Drainage Report Final_V1 REDLINES.pdf Markup Summary

Preliminary and Final DRAINAGE PLAN AND REPORT

ROCKY TOP MOTEL AND CAMPGROUND

County File No.: PPR2140

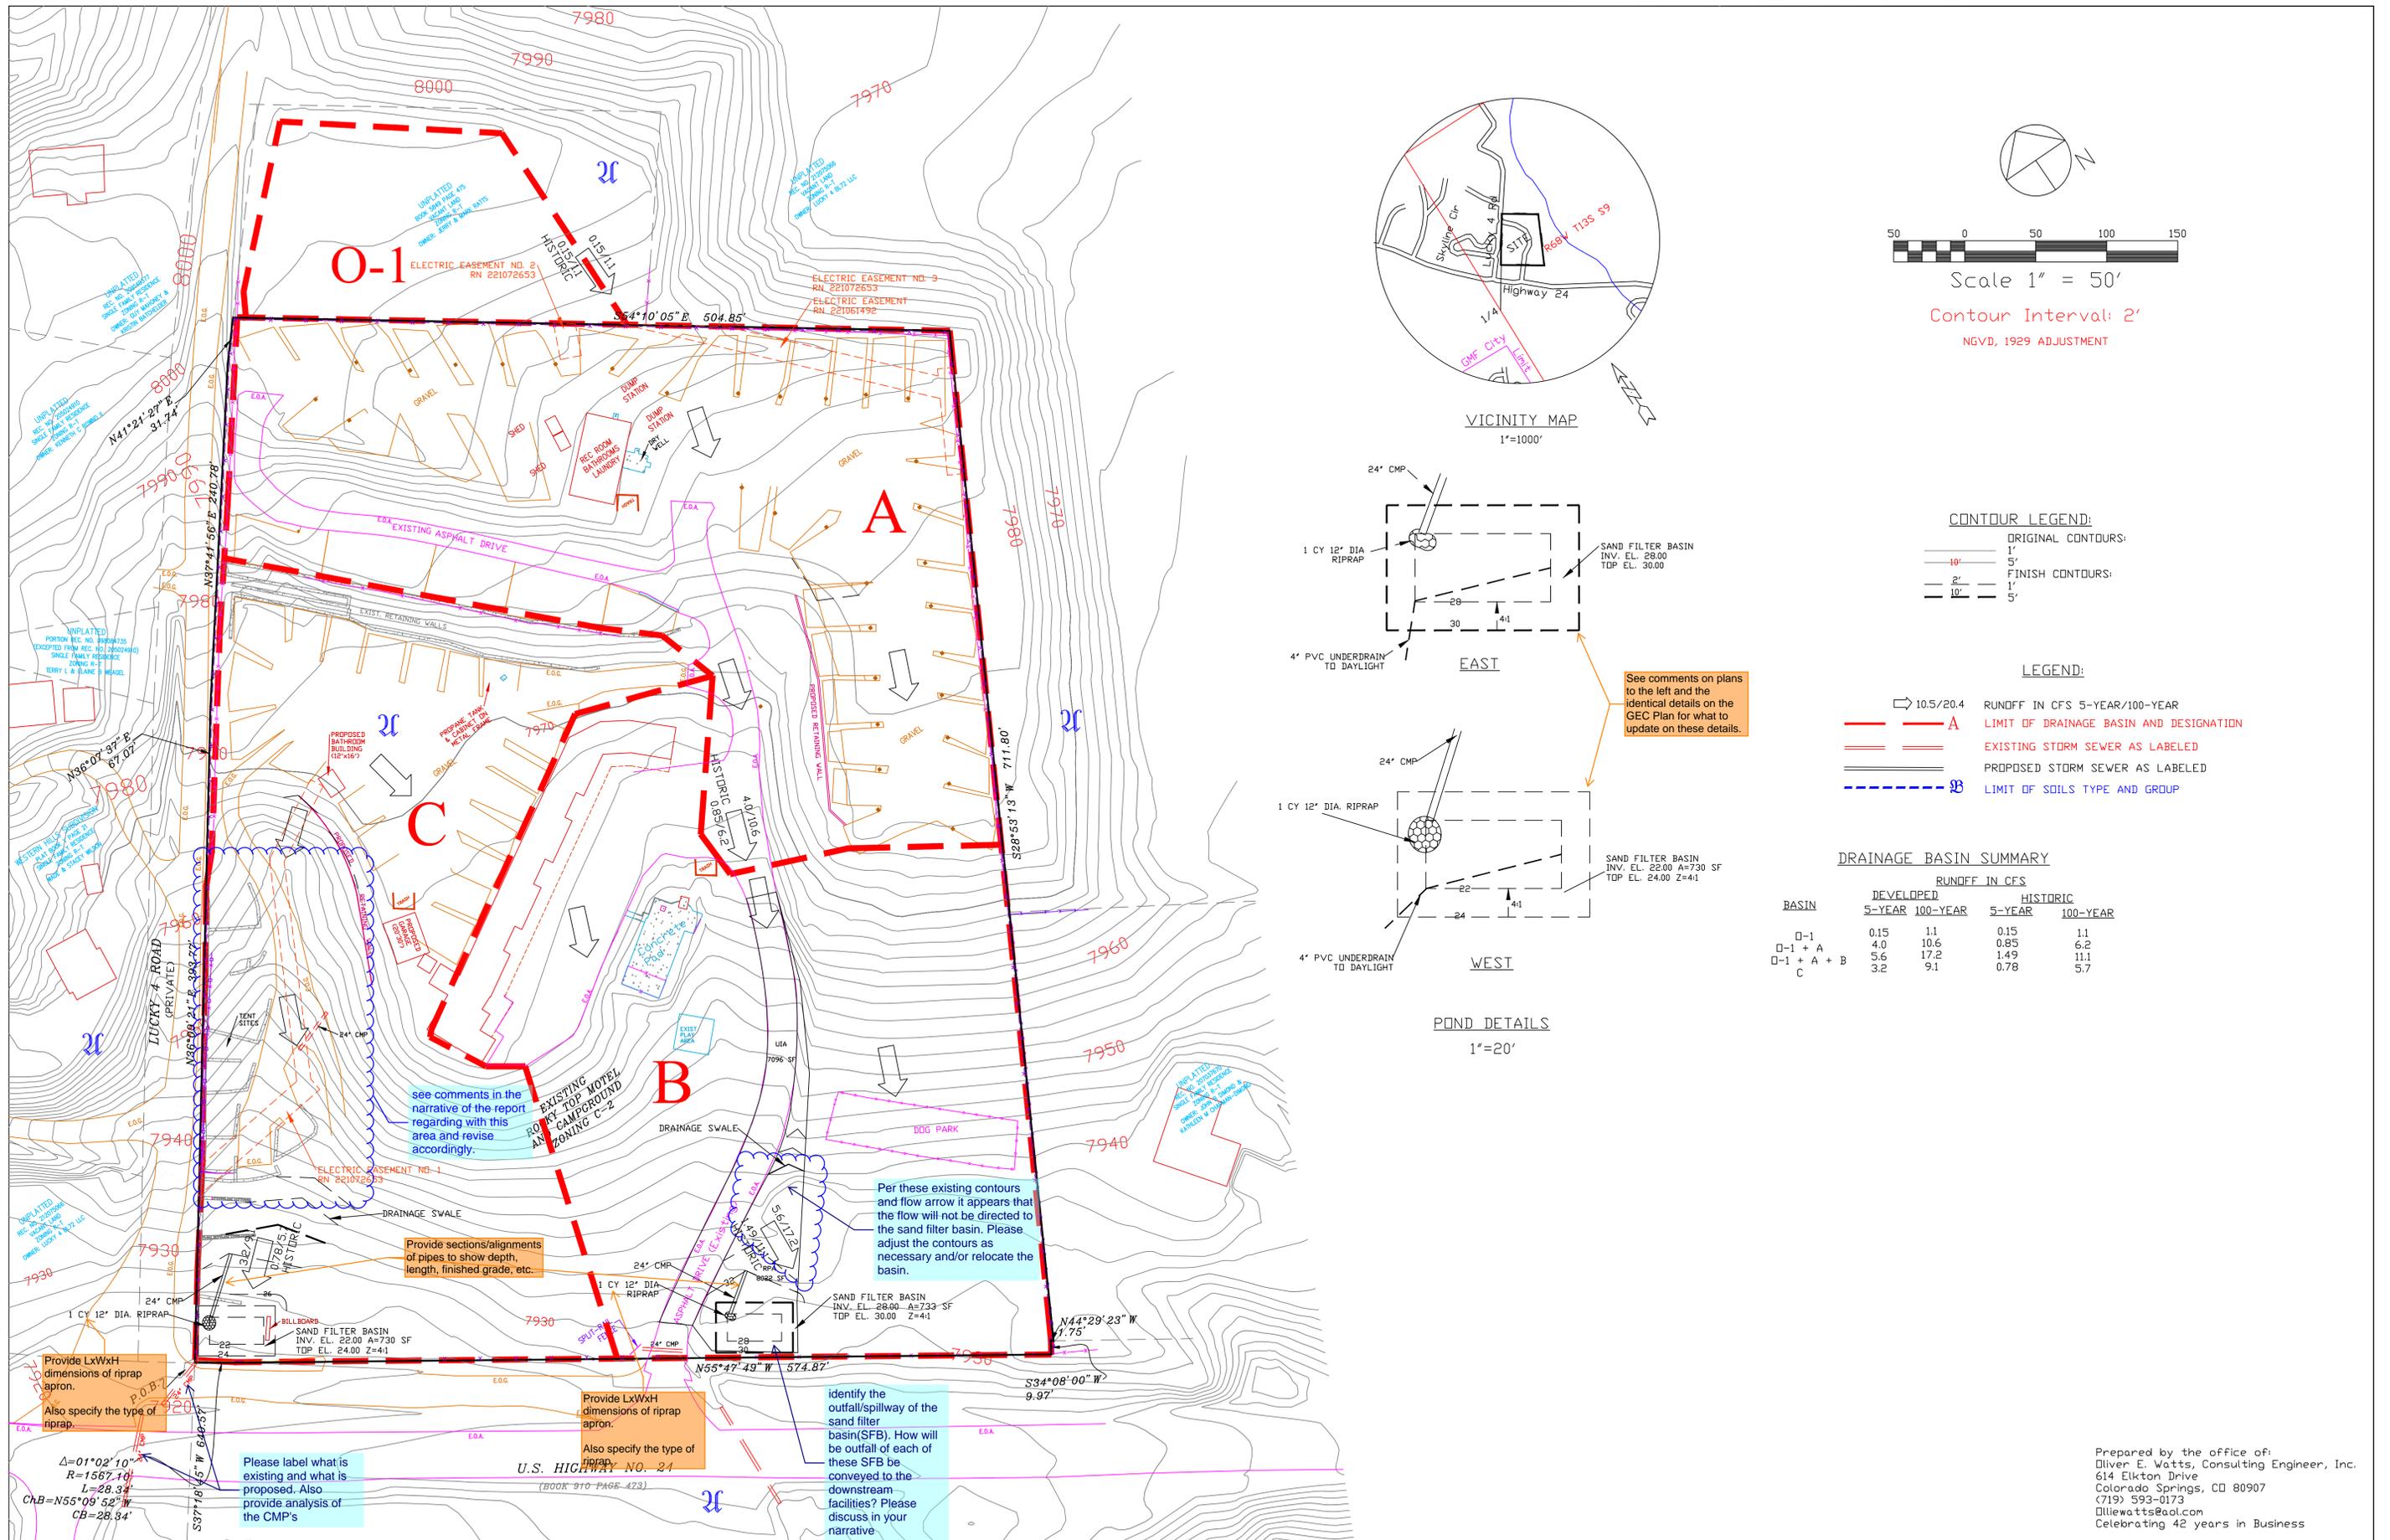
Per these existing contours and flow arrow it appears that the flow will not be directed to the sand filter basin. Please adjust the contours as necessary and/or relocate the basin.

Identify the outfall/spillway of the sand filter basin(SFB). How will be outfall of each of these SFB be conveyed to the downstream facilities? Please discuss in your narrative

See comments on plans to the left and the identical details on the GEC Plan for what to update on these details.

see comments in the narrative of the report regarding with this area and revise accordingly.

Provide sections/alignments of pipes to show depth, length, finished grade, etc.

Please label what is existing and what is proposed. Also provide analysis of the CMP's

Provide LxWxH dimensions of riprap apron. Also specify the type of riprap.

Provide LxWxH dimensions of riprap apron. Also specify the type of riprap.
